TECHNICAL BULLETIN

No. 427-02-04

SUBJECT: INTRODUCTION OF NEW HARDENED WEAR SLEEVE P/N 427-044-123-101.

FIGURE 1. FORWARD TAIL ROTOR DRIVESHAFT

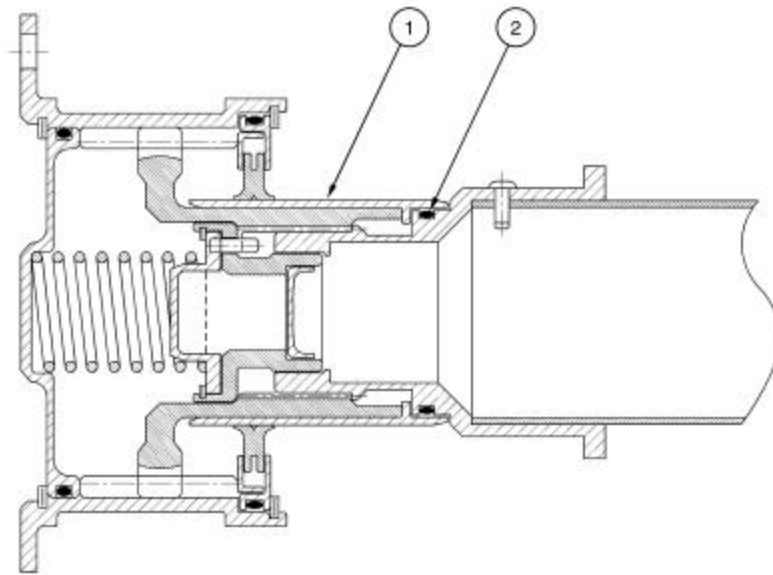
Field reports indicate that the wear sleeves P/N 427-044-117-101 installed on forward tail rotor driveshaft assembly P/N 427-044-100-103 tends to exhibit a premature wear groove.

This bulletin introduces an improved, hardened wear sleeve.

1. Remove forward driveshaft P/N 427-044-100-103 from aircraft per BHT-427-MM Chapter 65.
2. Disassemble driveshaft per BHT-427-MM Chapter 65.
3. Remove and discard wear sleeves P/N 427-044-117-101 and packing P/N M83248/1-130. (Refer to figure 1).
4. Reassemble driveshaft per BHT-427-MM Chapter 65 using new wear sleeves P/N 427-044-123-101.
5. Re-identify driveshaft data plate and historical service record from P/N 427-044-100-103 to P/N 427-044-100-103-105FM.
6. Install forward driveshaft P/N 427-044-100-105FM in the aircraft per BHT-427-MM Chapter 65.
7. Annotate records to reflect compliance with this bulletin.

- 1. Wear sleeve (427-044-123-101) (new improved)
- 2. Packing (M83248/1-130)
